Our Ref:
TR/2404920/RevA
27th March 2025

Land North of Thaxted Road, Saffron Walden - Response to Essex County Council Comments

Drawing Title: **CONCEPT DRAINAGE STRATEGY**

Drawing Number: **2404920-ACE-XX-XX-DR-C-0151**

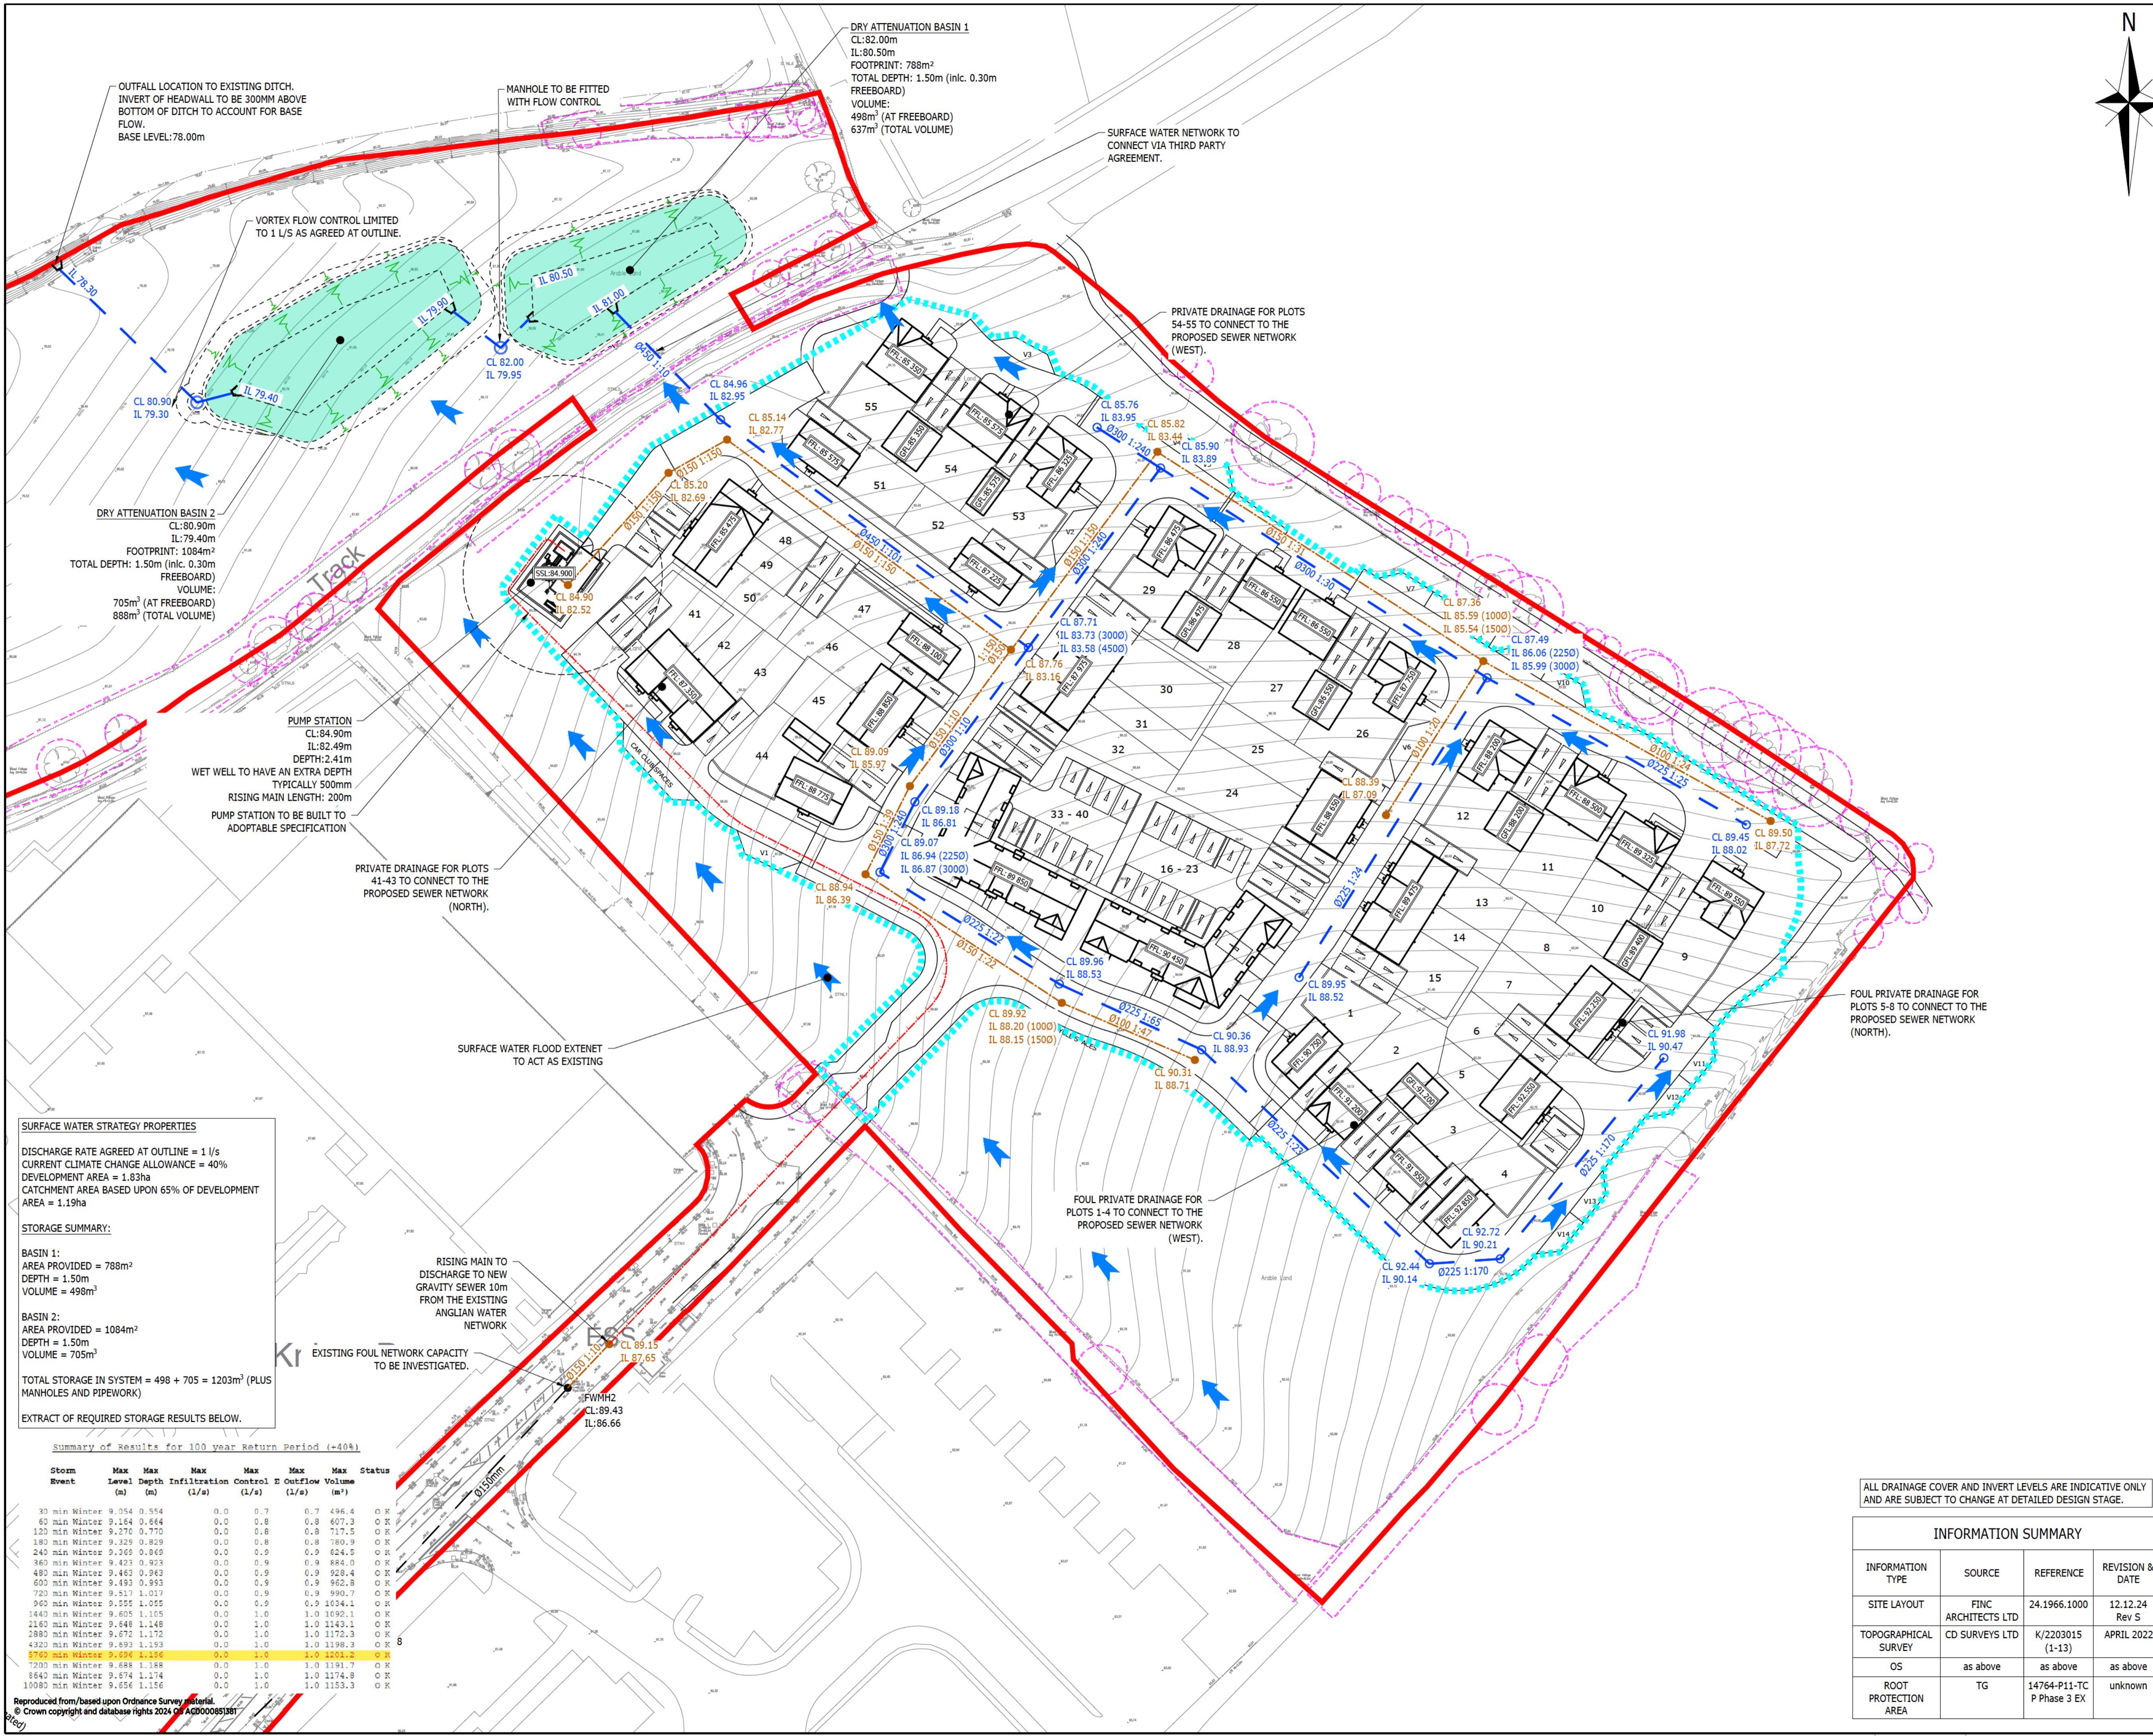
1. *Please provide a more detailed drainage plan which shows the connections to/from the property driveways and roofs and which demonstrates how these areas will receive treatment.*

All plots, driveways and other impermeable areas drain to the proposed sewer network. We have altered the leaders and notes on the plan to make this clearer. We are unable to provide the exact connections of above ground drainage as this is reserved for detailed design stage . Please see updated drainage strategy in **Appendix A**.

C	LEADER NOTES UPDATED	JTM	TR	BB	27.03.25
B	DRAINAGE REVISED TO SUIT UPDATED LAYOUT & LEVELS	DR	TR	BB	13.12.24
A	FIRST ISSUE	TR	TR	BB	31.10.24
Rev	Description	Drn	Chk	App	Date
